Re: Permissive Change Request

Model Name: BL871E2-HI
FCC ID: RFR-BL871
IC: 23249-BL871

Identifier Marking for OEM Bluetooth Module BL871E2-HI,

Attempt 1: FCC ID in 4points

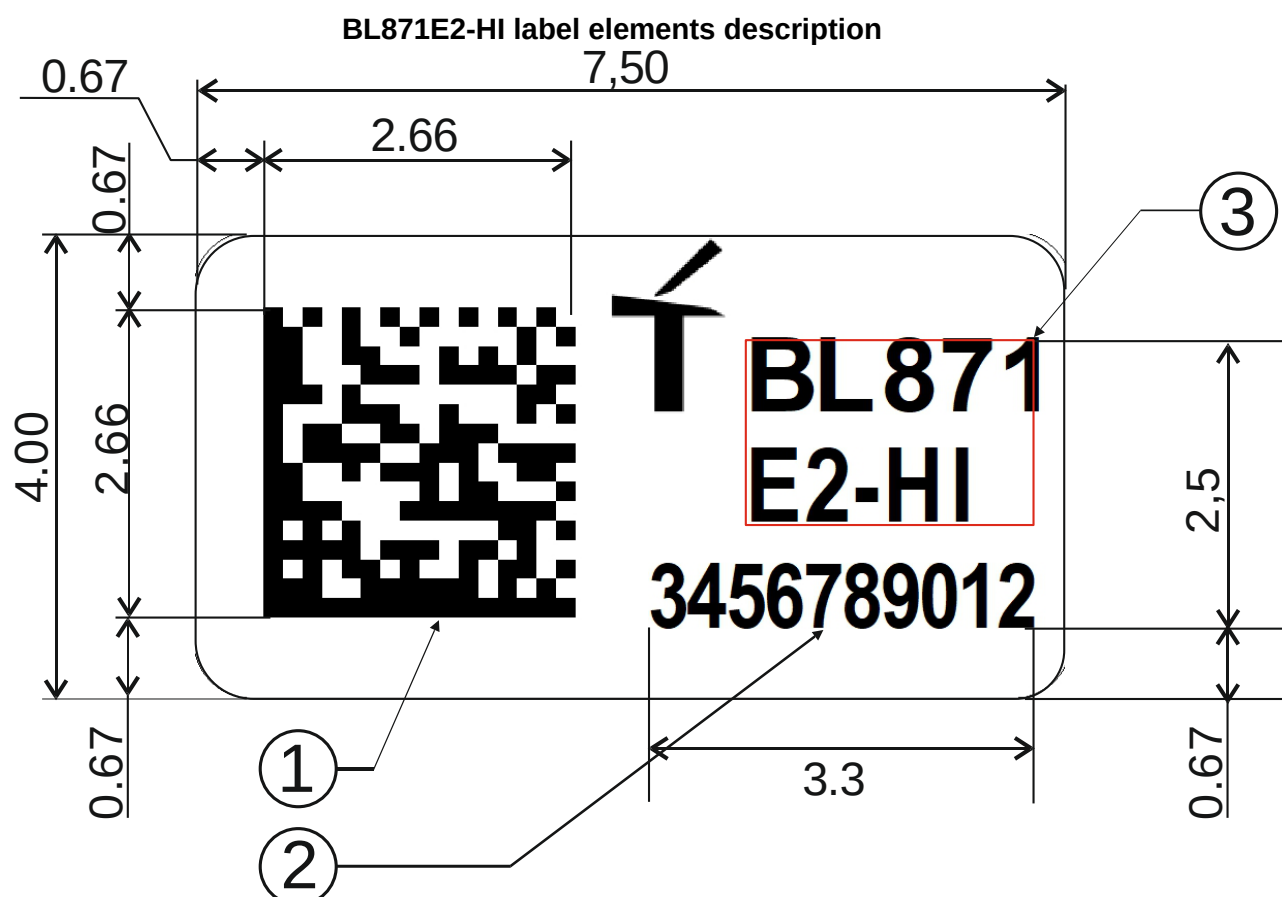
KDB784748 D01 §2.2 defines that it should be possible to print the FCC ID readable without magnifying glasses on the label. The minimum readable size is given with size of 4-6 points. Otherwise the Module manufacturer should ask the FCC for the permission to publish the FCC ID in the user manual. The following pictures show some attempts to place the FCC ID on the label.

2points is not readable without magnifying glasses, at least not for me.

If the requested permission was granted by the FCC, the device label specification would be
